## SERVICE BULLETIN: JSB 012-4

**Issue:** 4

**Date:** 21<sup>st</sup> December 2017

**Subject:** Jabiru Engine Flywheel Attachment

Figure 2 - Plain washers compared to Nordloc washers

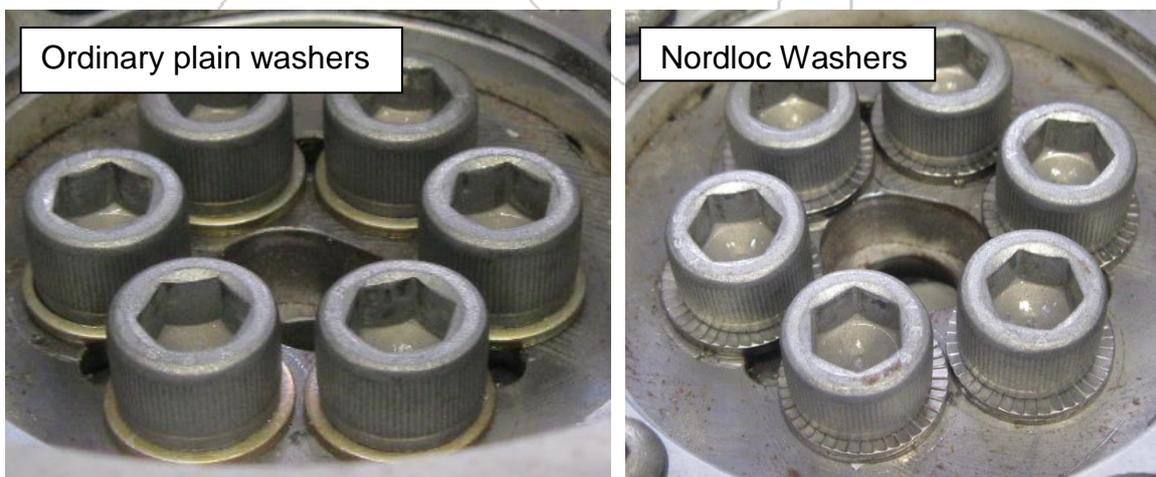
This revision of this service bulletin also acts to inform maintainers and operators of a design change to the flywheel connection which should be implemented on existing engines whenever flywheel bolts are replaced (i.e. at the intervals specified in JEM0002 or at overhaul).

Flywheel screws must now be installed using Nordloc washers (replacing the previous installation which used either plain or Belleville washers). Jabiru engines of any and all flywheel configurations (as defined in Table 1) should now use Nordloc washers. These washers are easily identified via visual inspection as shown below in Figure 2.

Refer to the Jabiru Engine overhaul manual JEM0001 (always check for the latest revision) for the installation procedure of flywheel capscrews using Nordloc washers. The major difference in installation is that bolts installed with Nordloc washers **must not be installed with Loctite**. The torque setting is also different for capscrews installed with these washers
